# Groundwater Application Review Summary Form

Application # G- 18601

# MEMO

**To:** Kristopher Byrd, Well Construction and Compliance Section Manager  
**From:** Joel Jeffery, Well Construction Program Coordinator  
**Subject:** Review of Water Right Application G-18601  
**Date:** September 19, 2018

### Water-Level vs Usage

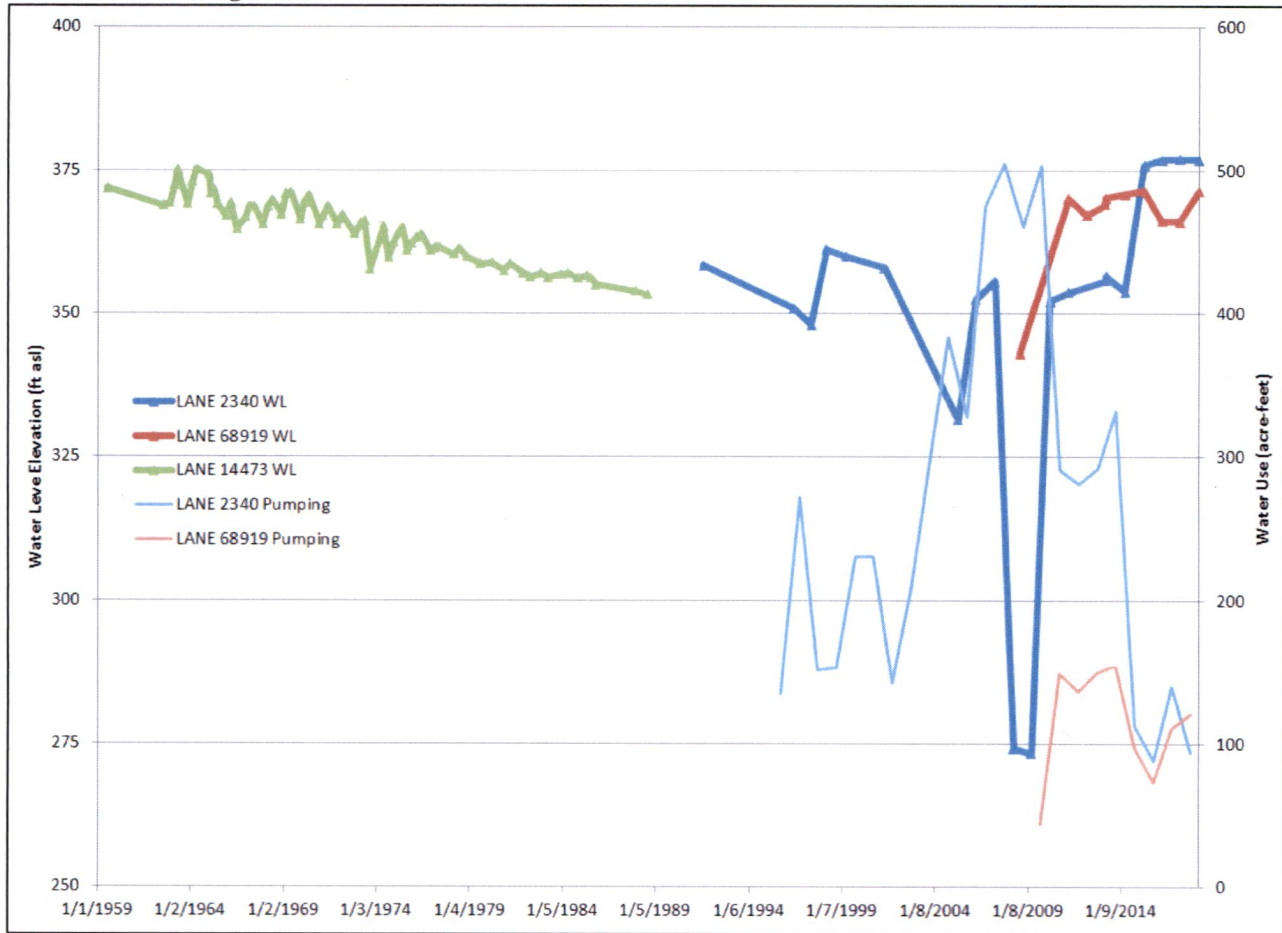
The wells in the area develop water from sands and gravels associated with the weather terrace gravels (unit QTg of O’Connor, et al., 2001). Groundwater and surface water are hydraulically connected in this environment. Due to this connection, the long term supply should be relatively stable. However, water levels from nearby wells, including the City of Veneta well #9 (LANE 2340) and #11 (LANE 68918), show a downward trend between the 1960’s through the 1980s, then a leveling off, and then a jump back to higher water levels in the 2010’s. The water level trends appear related to the amount of water being pumped (see Water–Level vs Usage and Water–Level vs Precipitation charts below).

Due to the relatively low hydraulic conductivity of the area, water levels measured in any well may be related to more to local pumping rather than being indicative of the aquifer in that region. Interference with nearby users could be a problem. However, it is impossible to predict if interference will occur without spending considerable time locating nearby wells.
